**Addendum to technical appendix F: Transport assessment**

*Land East of Park View, Woodstock*

*Response to Highway Authority*

*LPA Reference 25/01510/OUT*

*Figure 1 Route to Marlborough School*

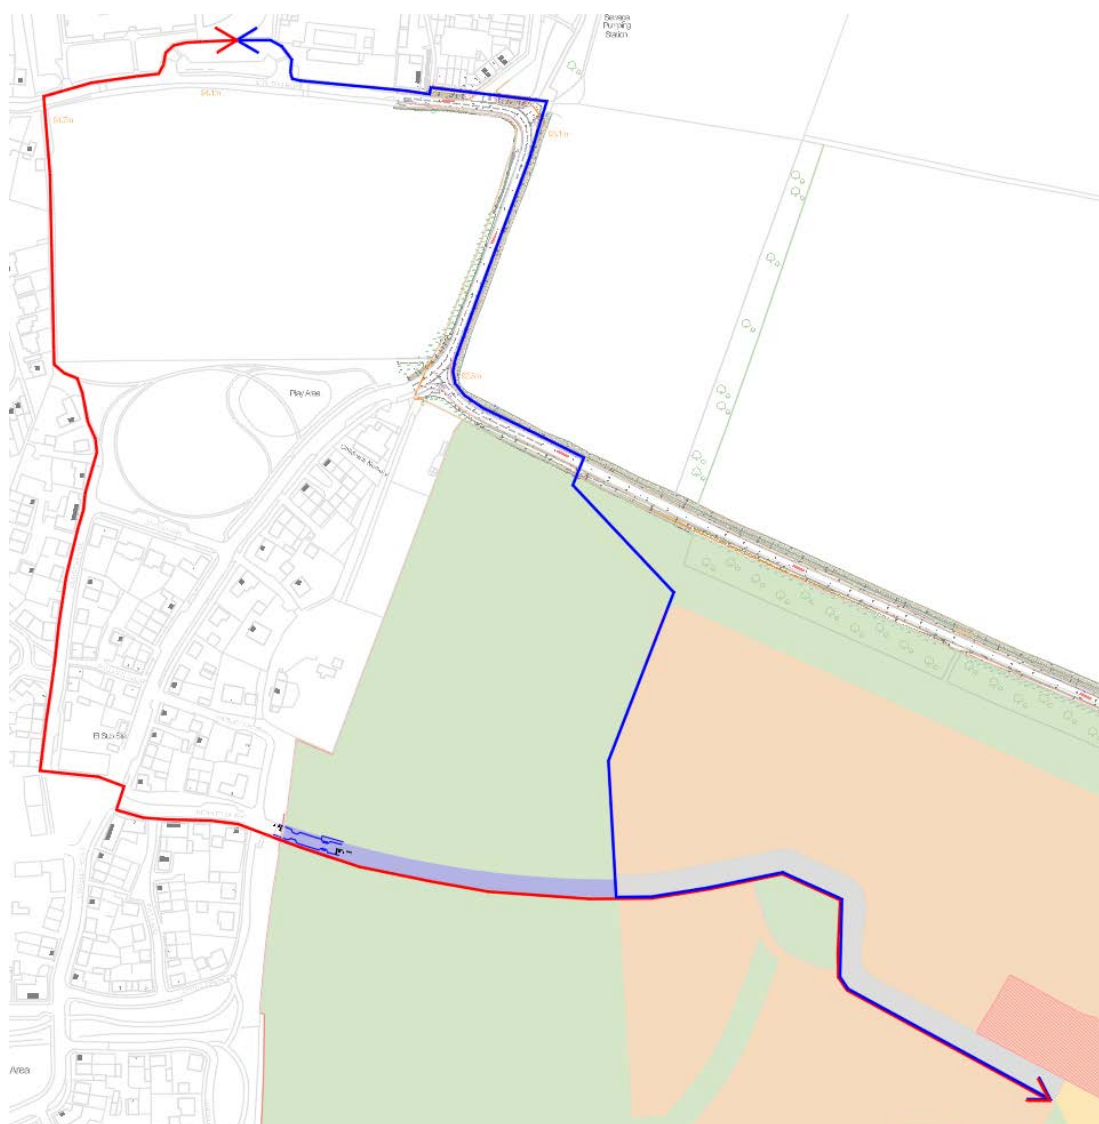
*In addition, the site must provide a link to the northwest of the development, at the Cowells Road junction with Shipton Road appreciating that this is most direct route for school trips from this site. This would link onto the infrastructure identified as Route 26 in the Woodstock LCWIP as footway providing a link from the north of the Park View estate to Marlborough School.*

- 2.8 An assessment of the routes between the development and the schools has been undertaken with reference to LTN 1/20 design principles, which specify that walking and cycling routes should be coherent, direct, safe, comfortable, and attractive with these criteria considered collectively rather than in isolation.
- 2.9 The approved route from the development at Park View to Shipton Road and the schools is illustrated on the approved Movement Masterplan (Ref. 16/01364/OUT), included at **Appendix D**. This route provides a continuous and legible connection to Shipton Road and onward to both the primary and secondary schools through a low-speed, low-traffic environment with lighting and good natural surveillance.

- 2.10 Although the route is marginally longer than the straight-line alignment, the additional distance is limited. **Figure 1** demonstrates the route from the local centre to the schools via Park View is only marginally (140 metres) longer than via Shipton Road. In accordance with LTN 1/20, the quality, safety and attractiveness of the Park View route are considered to outweigh this small difference in distance, and the entire development remains within convenient walking distance of the schools.

JOB TITLE		SOUTHEAST WOODSTOCK		CLIENT		BLENHIEM PARTNERS	
DRAWING TITLE							
A44 BLADON ROUNDABOUT PROPOSED ACTIVE TRAVEL FOCUSED IMPROVEMENTS GENERAL ARRANGEMENT							
SCALE	DRAWN BY	DATE	DRAWING No	REVISION			
1:500@A1	RJM	03/12/25	23570-05-GA2	E

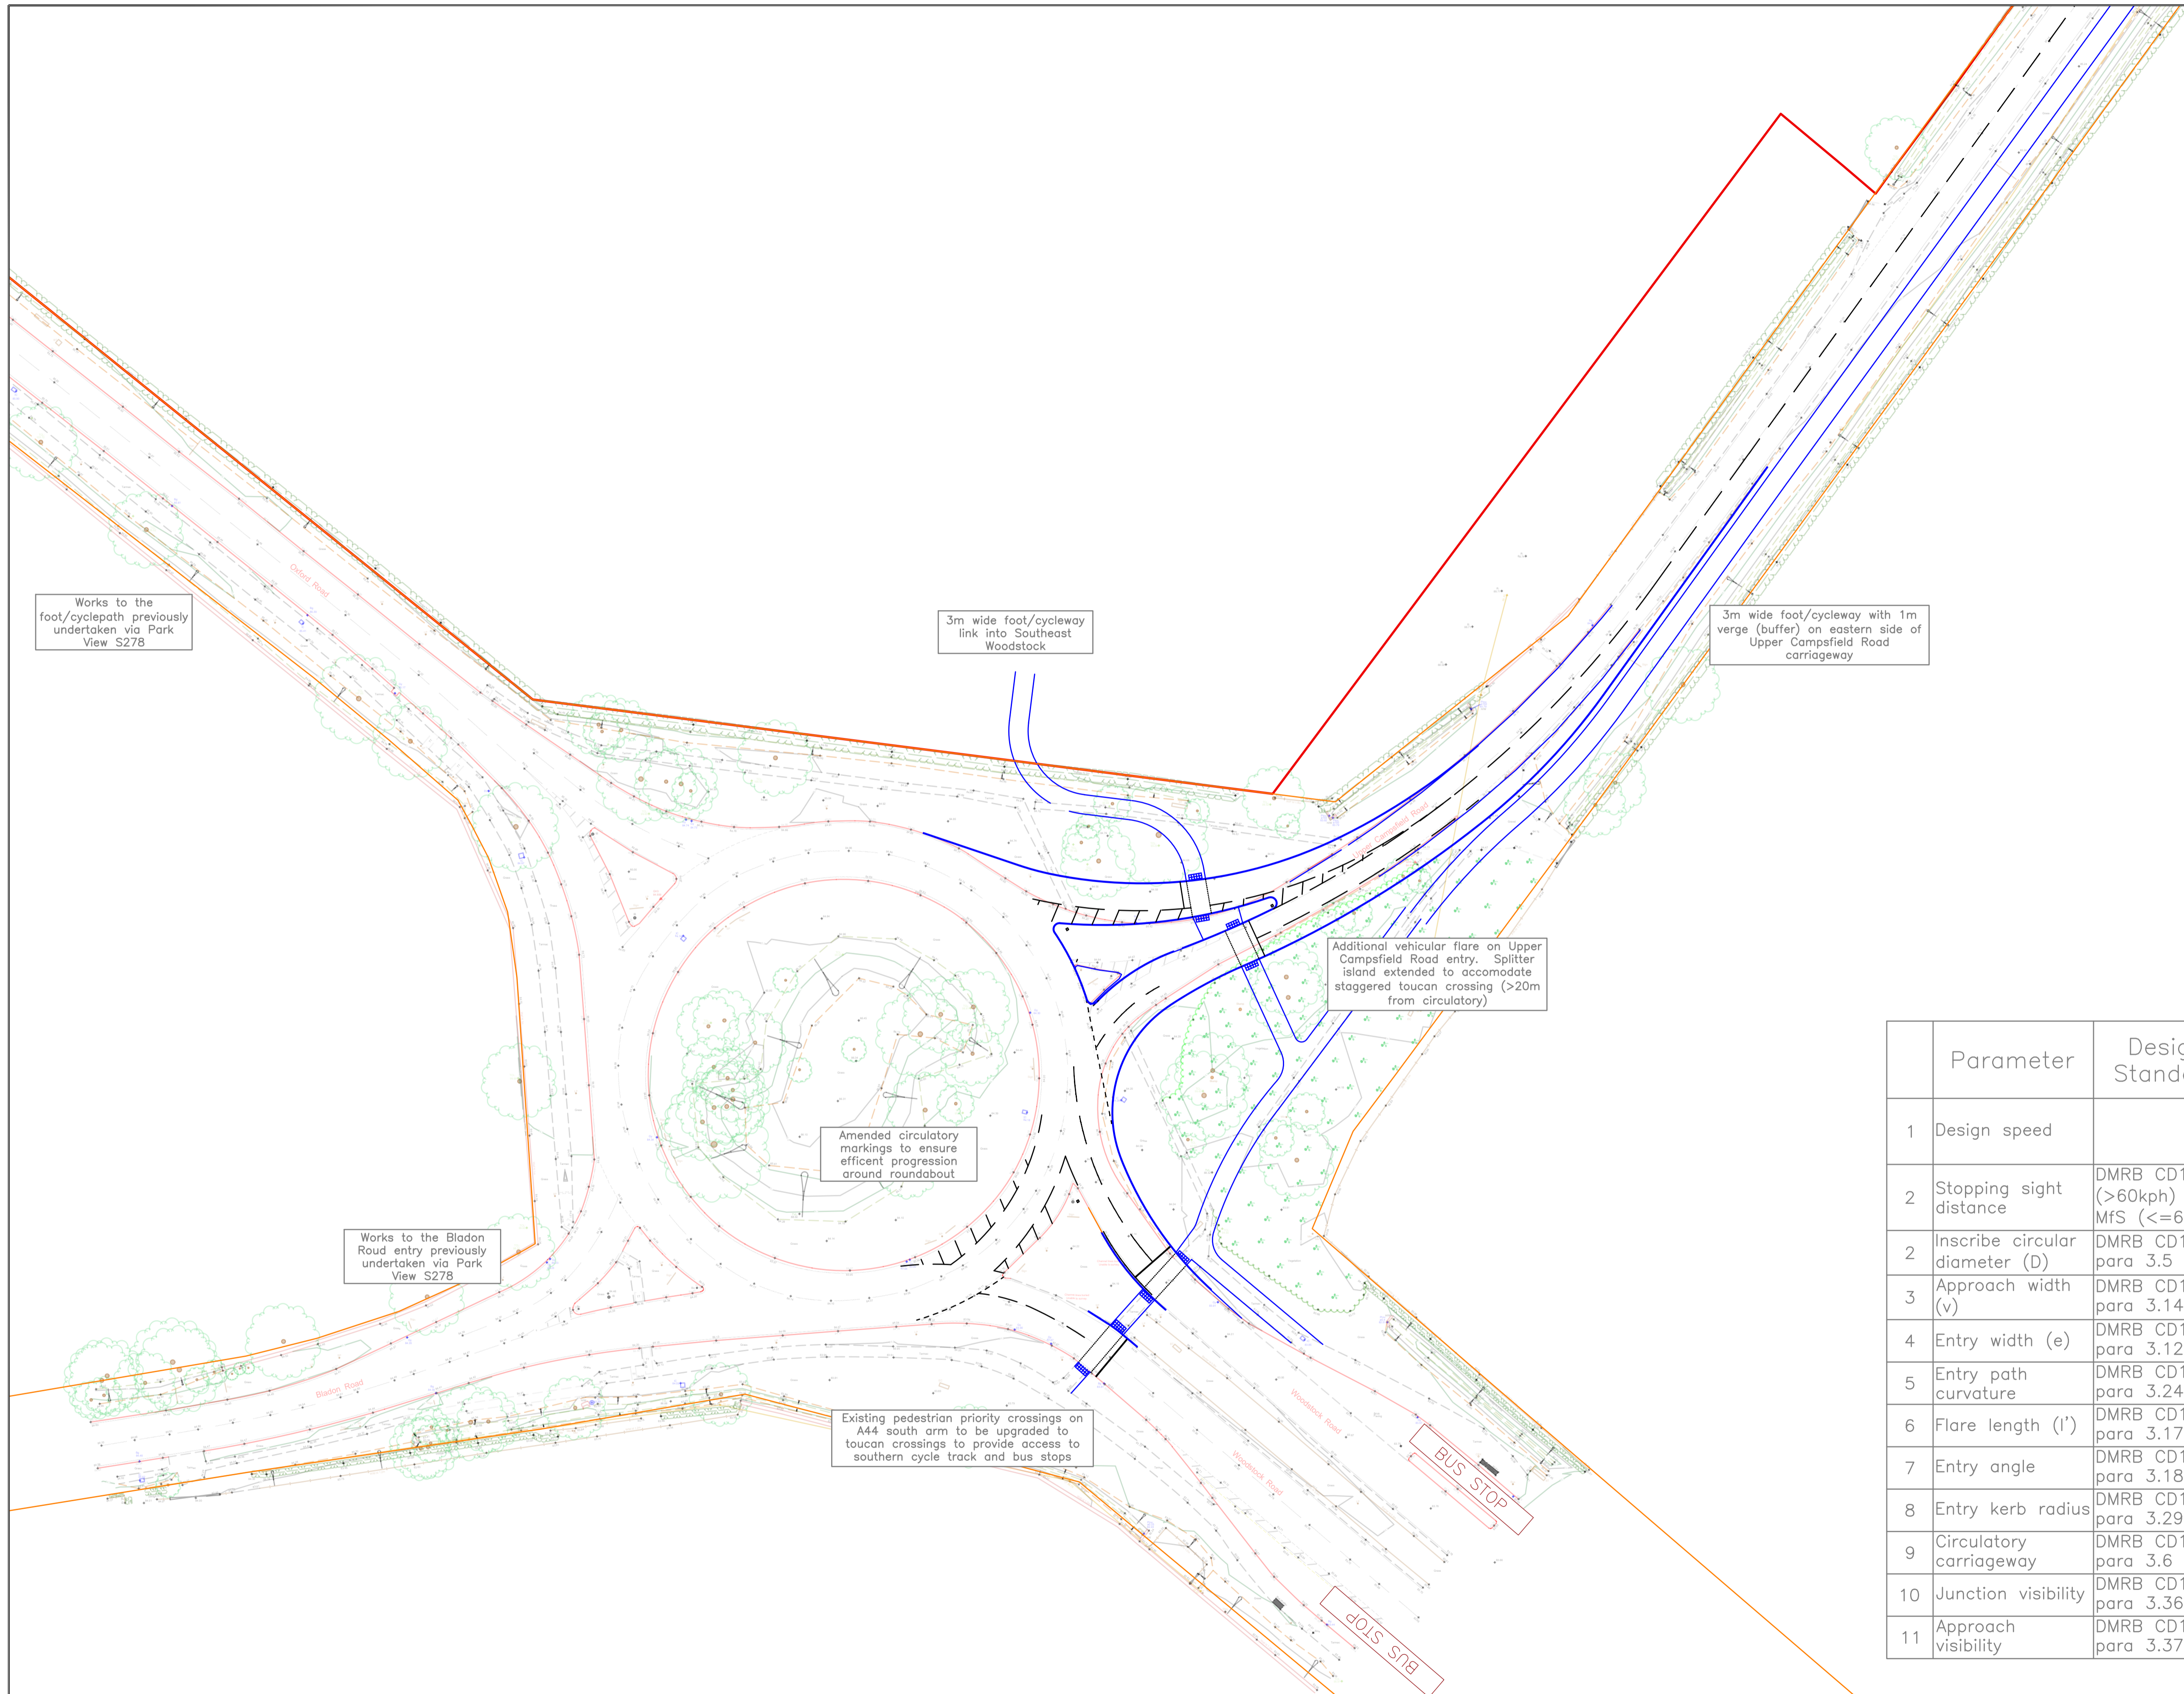
*In addition to this, I question the suitability of the crossing to the south of the new roundabout as it has the potential for a higher demand than the others. Interrogation of Table 10-2: Crossing design suitability of LTN 1/20 shows that a signalised crossing is required to enable pedestrians and cyclists to safely cross the highly trafficked A4095. In this respect, I expect to see at least the southern arm of the new access roundabout signalised or the stand alone crossing that has been set back from the access to be signalised.*

1.5 The proposals are shown on **DTA Drawing 23570-05E-GA2**.

Existing pedestrian priority crossings on A44 south arm to be upgraded to toucan crossings to provide access to southern cycle track and bus stops

DRAWING TITLE: UPPER CAMPSFIELD ROAD ACCESS GENERAL ARRANGEMENT

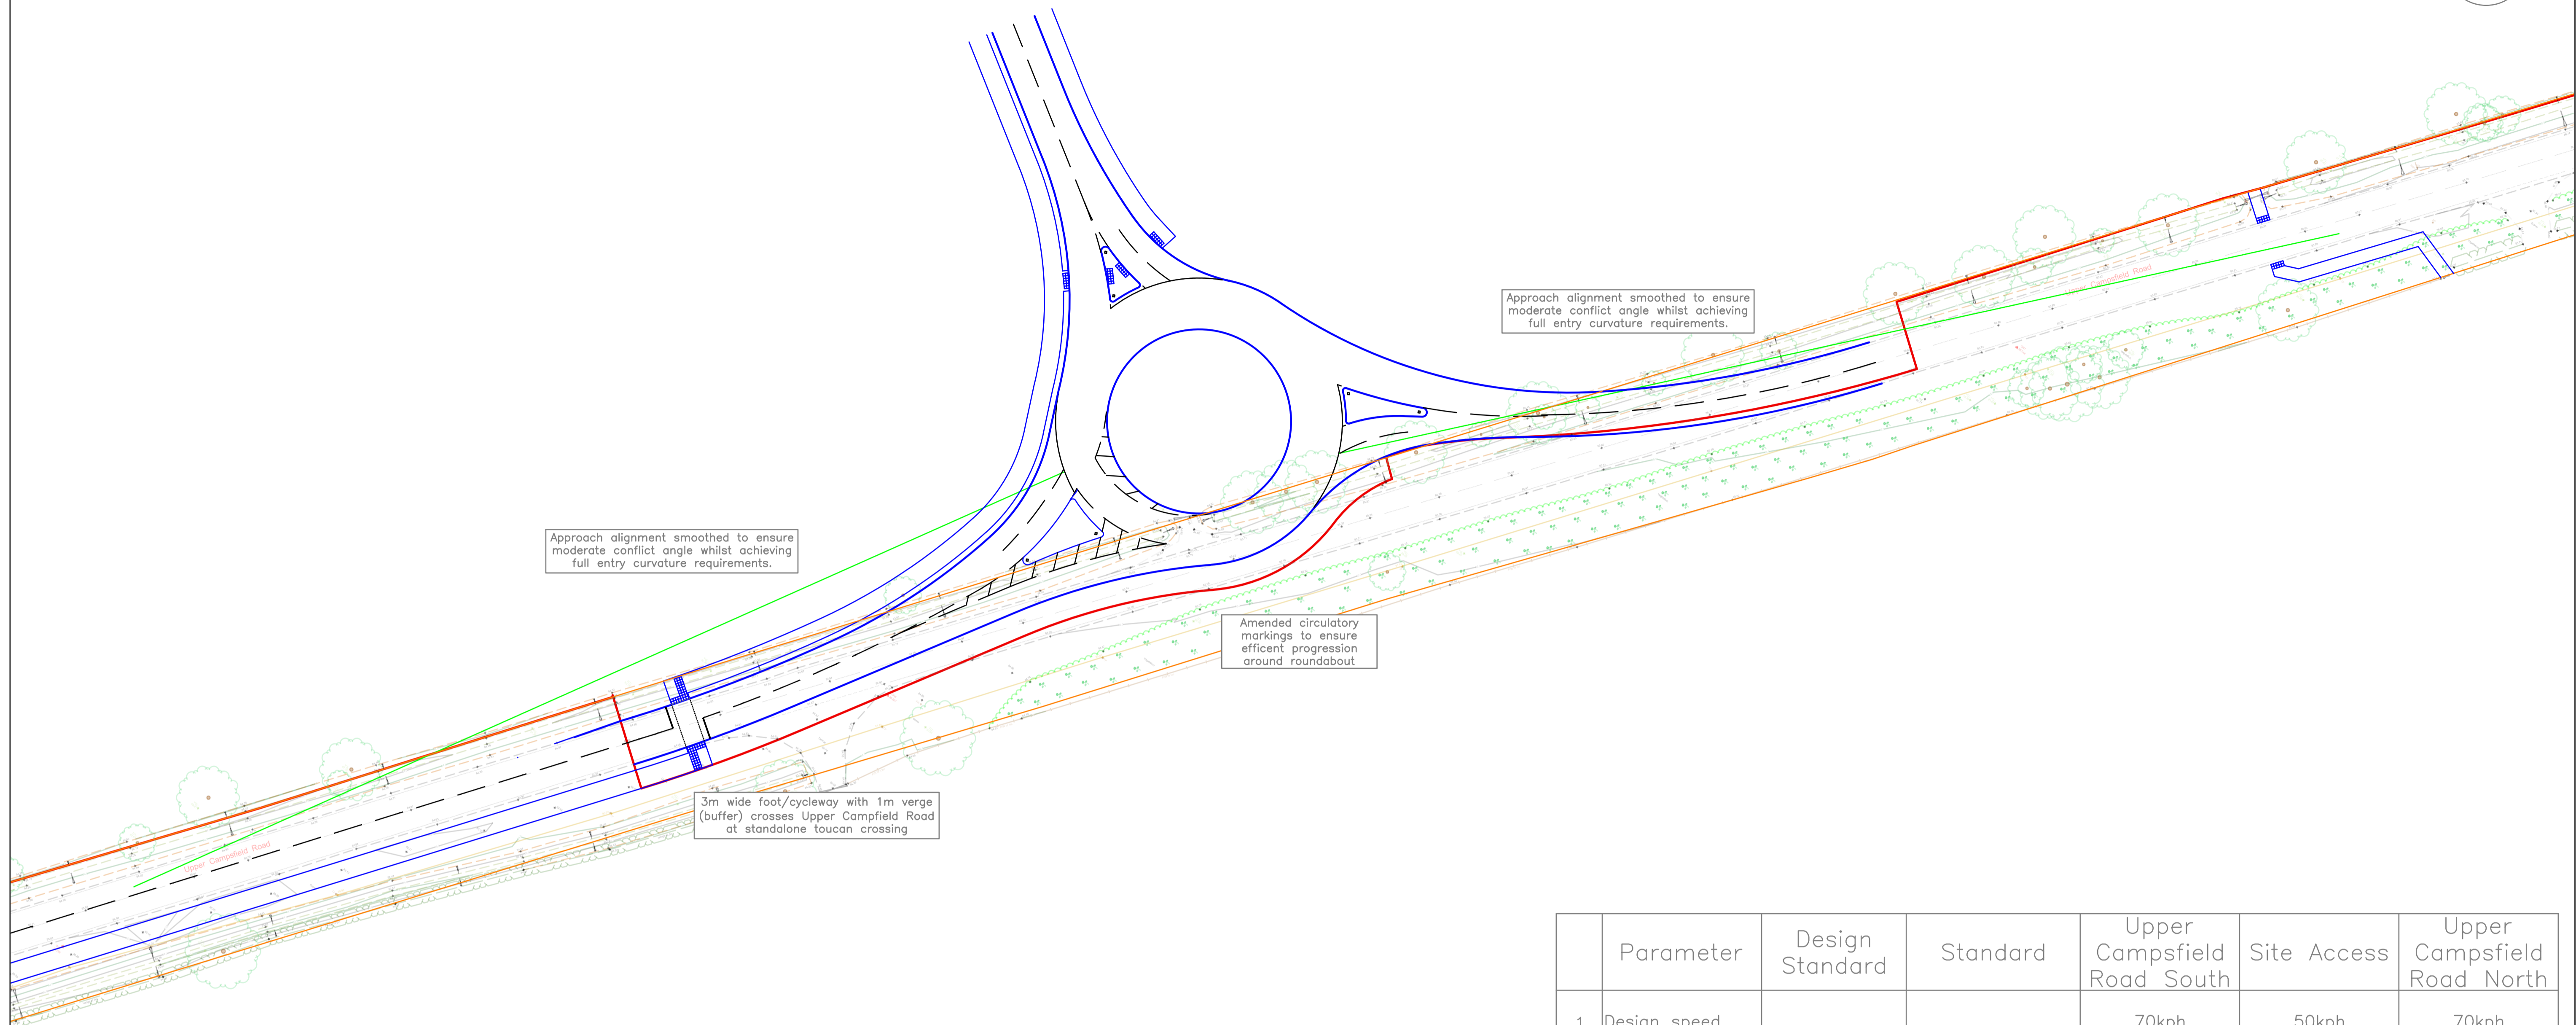
*The access roundabout includes informal crossings across refuge islands on all the three arms of the roundabout. The sizes of these refuge islands appear unacceptably small to allow for cyclists to momentarily rest whilst waiting for a gap in traffic. Due to the access plans being appended to the TA, the geometrical scales that enable me to carry out measurements is thus impossible. The applicant must submit separate access arrangement plans to enable an accurate appraisal in this respect.*

*OCC Response:*

2.2 The crossings at the roundabout have been rationalised to correspond to the desire lines therefore whereas there was both priority crossings at the splitter islands and a standalone traffic signal-controlled pedestrian crossing on the Upper Campsfield Road, the priority crossings are no longer proposed so that pedestrians use the safest crossing option. Notwithstanding this, in response to OCC's request for scalable access drawings, a full set of dimensioned General Arrangement plans for the A4095 access roundabout has now been submitted. These drawings enable verification of all geometric parameters, including visibility splays, lane widths, flare lengths and island geometry. The pedestrian/cycle refuge island on the site access arm has been reviewed against CD116 and the minimum width requirements for cycle users, and the submitted GA drawings confirm that all refuge widths comply with the standards applicable to uncontrolled two-stage crossing locations. No departures from standard arise in respect of refuge geometry.

- 2.7 OCC requests that a pedestrian and cycle connection be provided to Public Footpath 265/36/10, located to the north of the access roundabout. The feasibility of providing such a link has now been reviewed, including land ownership, levels and highway boundary considerations. It is proposed to provide a pedestrian connection between the development, from an existing site access point, with a new dropped kerb crossing, to connect to the existing stile entrance to the footpath. This is shown on **Drawing 23570-05e-GA3**.

Approach alignment smoothed to ensure moderate conflict angle whilst achieving full entry curvature requirements.
